**DECLARATION OF BRADLEY J.
HERREMA IN SUPPORT OF MOTION
FOR COURT TO RECEIVE AND FILE
THE 2024/2025 ANNUAL REPORT FOR
THE GROUND-LEVEL MONITORING
PROGRAM**

Appendix A: Recommended Scope of Work and Budget of the Ground-Level Monitoring Committee for Fiscal Year 2025/26
Appendix B: Response to GLMC Comments

2024/25 Annual Report for the GLMP

Photo 2-1: Full SAR Collection Area
Google Earth, Landsat/Copernicus 2020

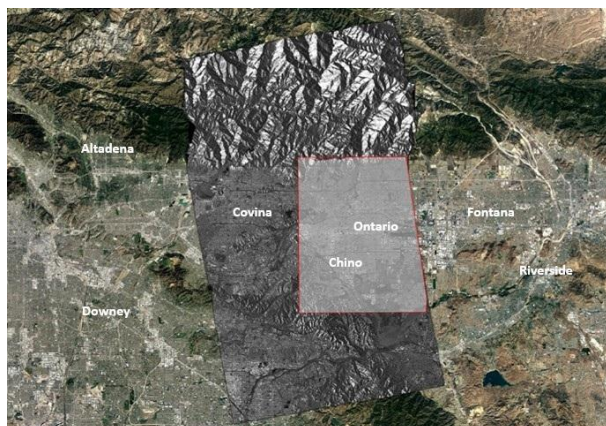
Comment 1 – Section 2.1.2.3: Monitoring Vertical Ground Motion, Photos 2-1 and 2-2

Photos 2-1 and 2-2 are difficult to interpret. The boundary of the “Full SAR Collection Area” on Photo 2-1 does not stand out clearly from the base image, and both photos might benefit from having labels added to a few readily-identifiable features.

Photos 2-1 and 2-2 have been updated with features to provide improved spatial reference. Next year’s annual report will include a new figure of the SAR coverage area with improved spatial reference.

Figure 3-6
History of Land Subsidence
in Southeast Area

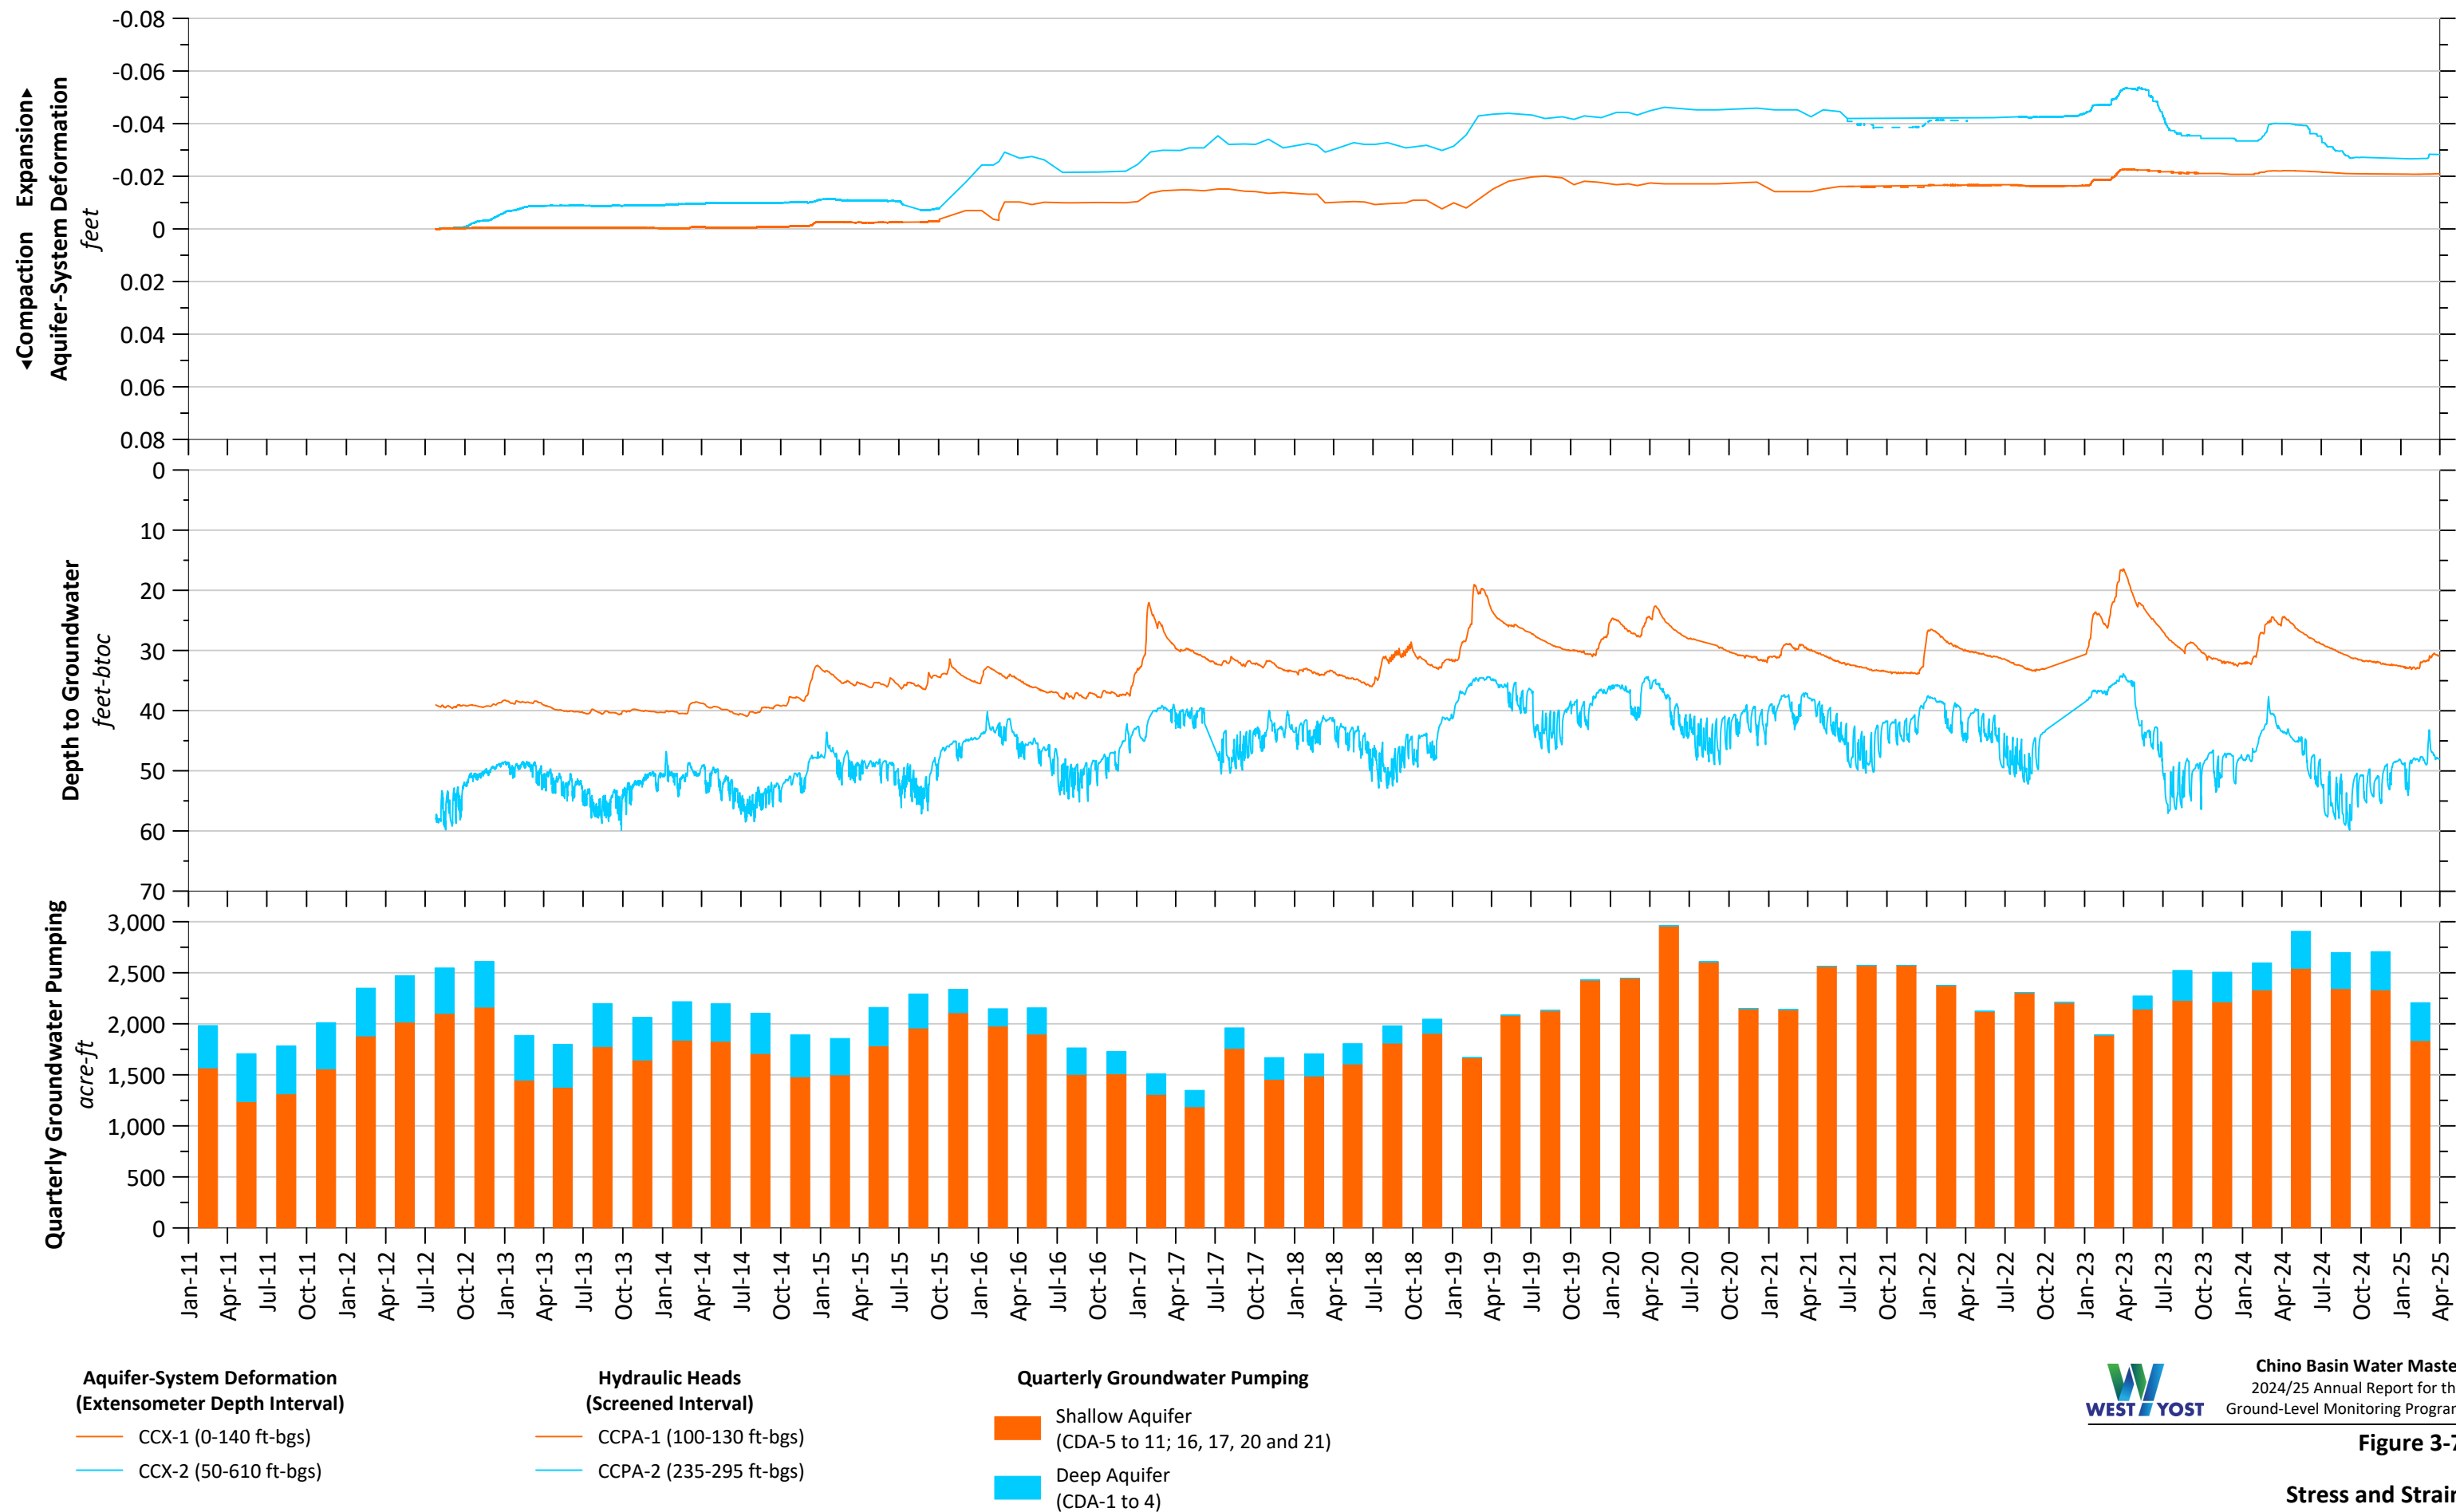
Comment 10 – Figure 3-6: History of Land Subsidence in Southeast Area

However, this is a reasonable suggestion and recent improvements in InSAR data processing have made it possible to generate more reliable subsidence estimates in this area. In future annual reports, the Watermaster Engineer will attempt to identify a reliable location in the Southeast Area to extract InSAR data for inclusion in Figure 3-6, allowing comparison with the Chino Creek Extensometer and benchmark data.

Figure 3-9a
History of Land Subsidence
in Northwest MZ-1

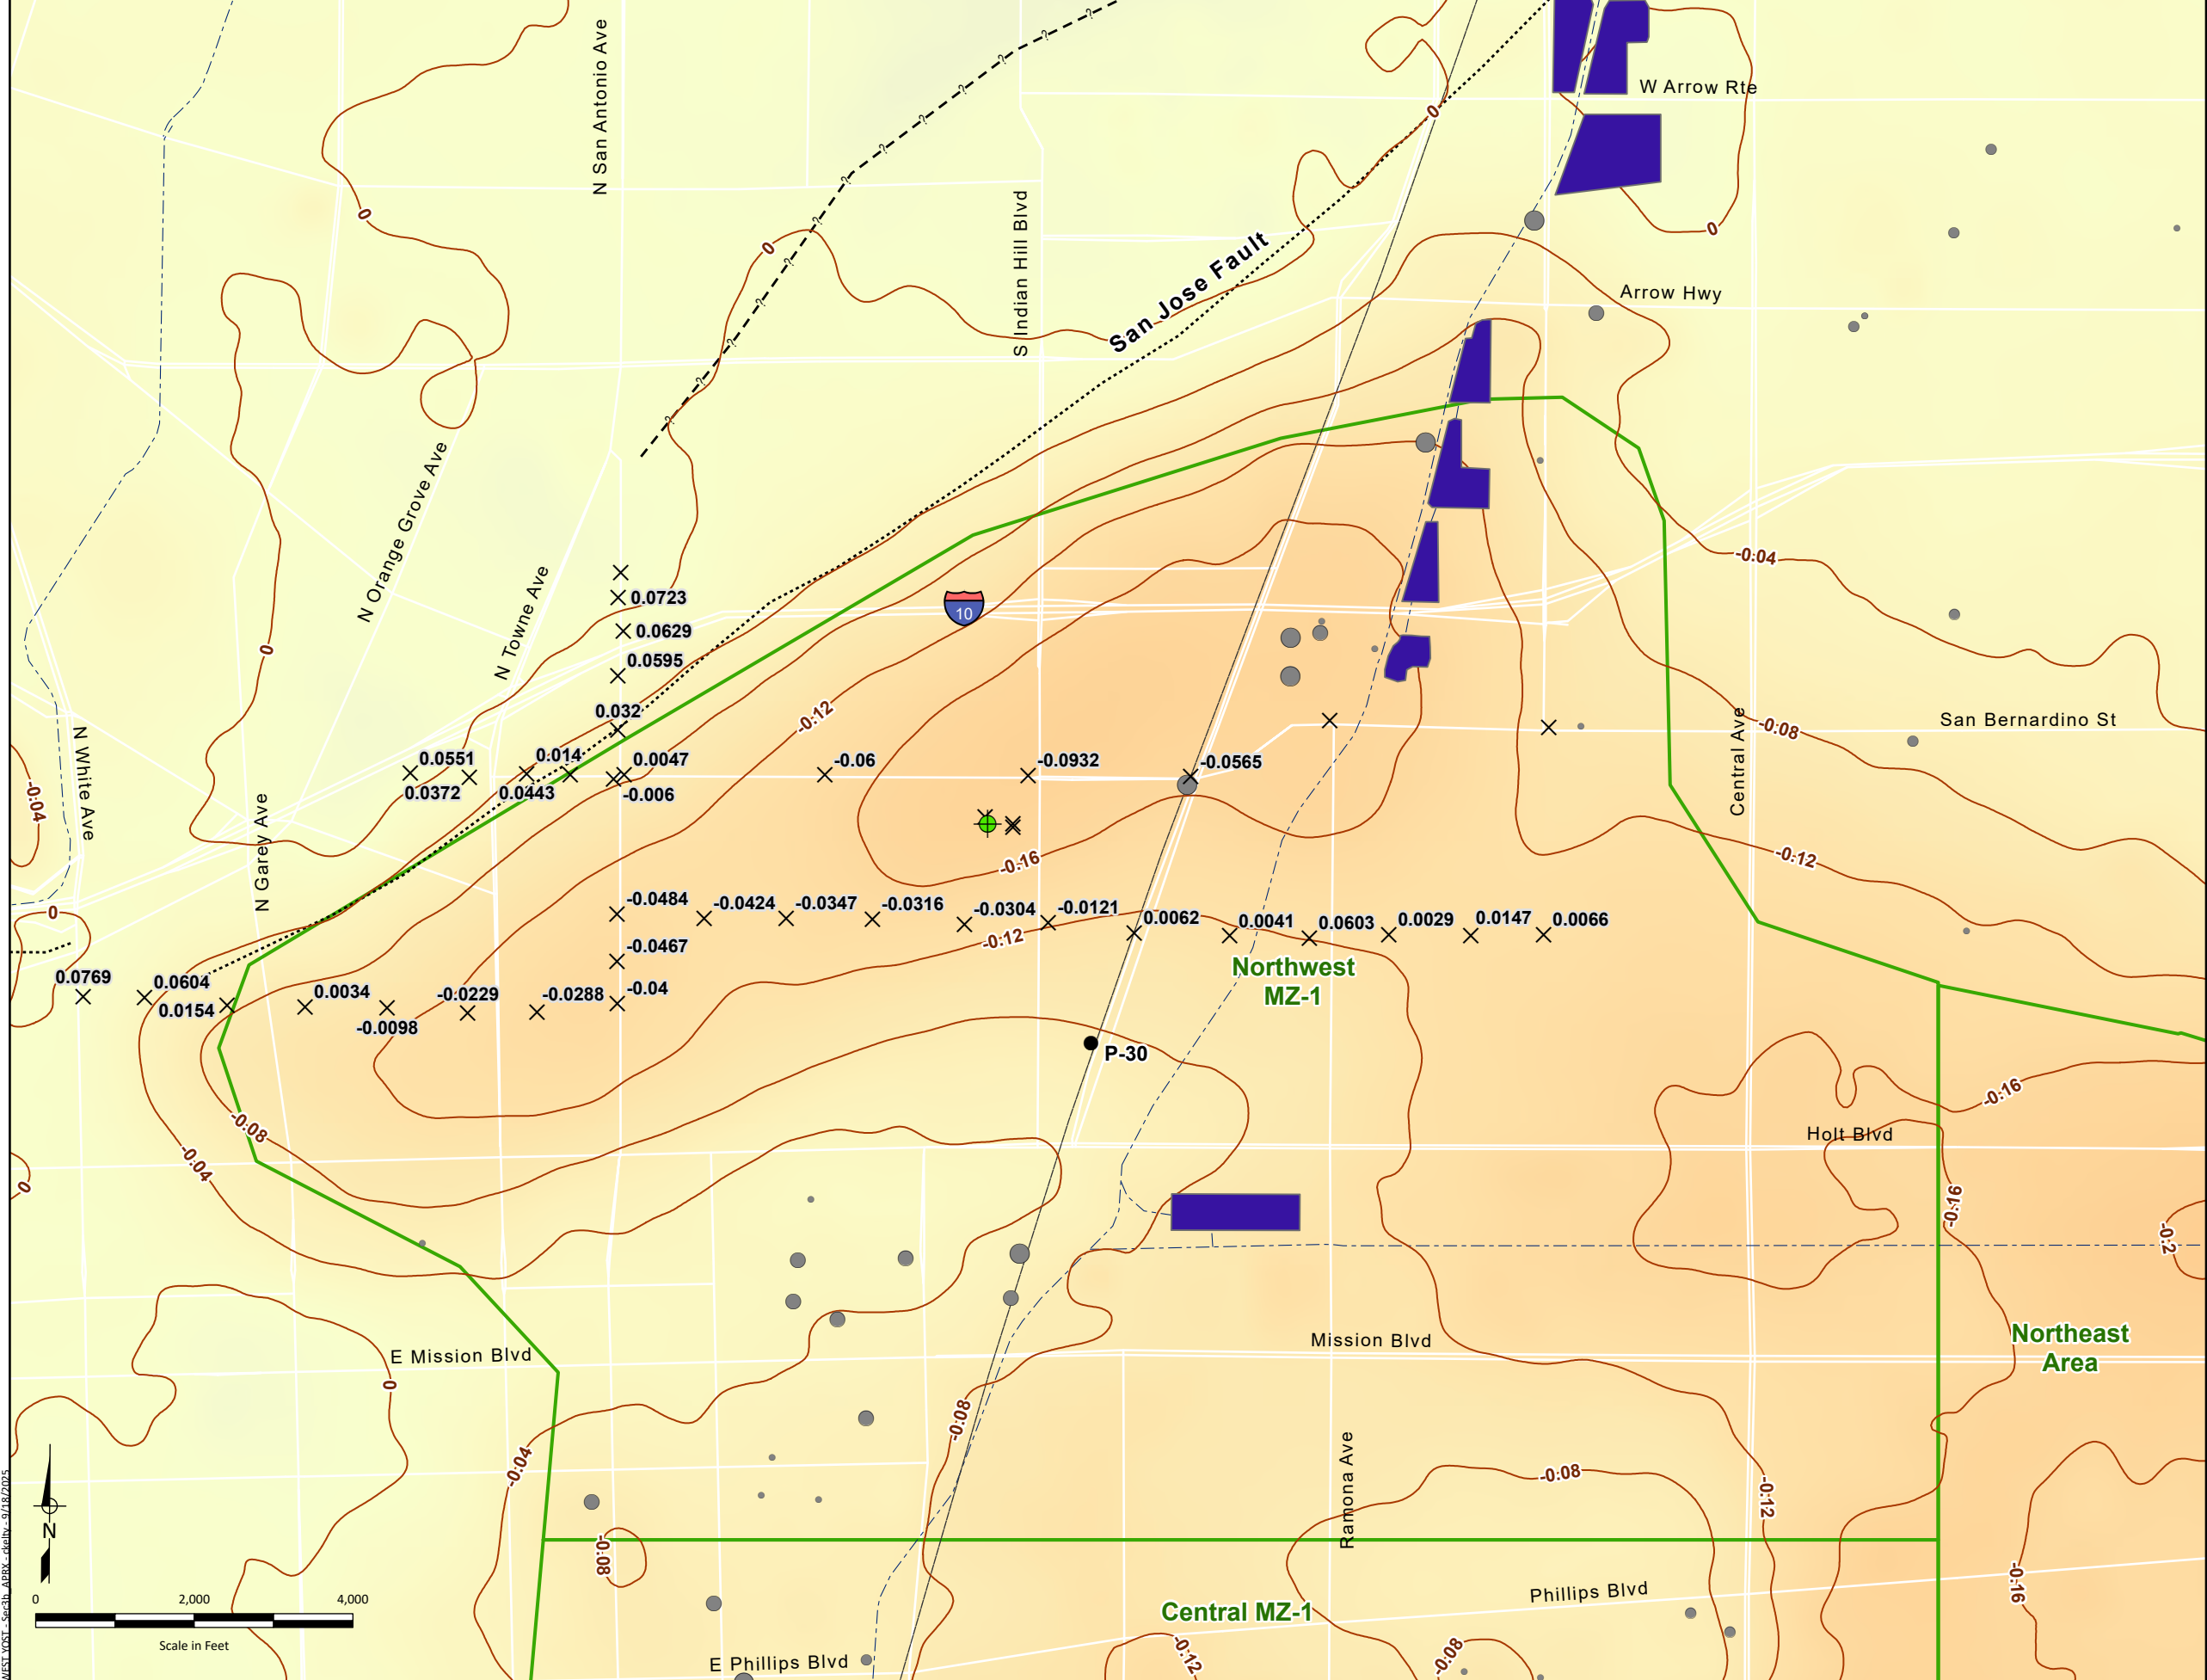
Comment 8 – Figure 3-9a: History of Land Subsidence in Northwest MZ-1

Data from BM B-403 indicates land subsidence trends have stabilized since 2018, while InSAR indicates a continued decline. Please discuss in more detail in the discussion of Figure 3-9a?
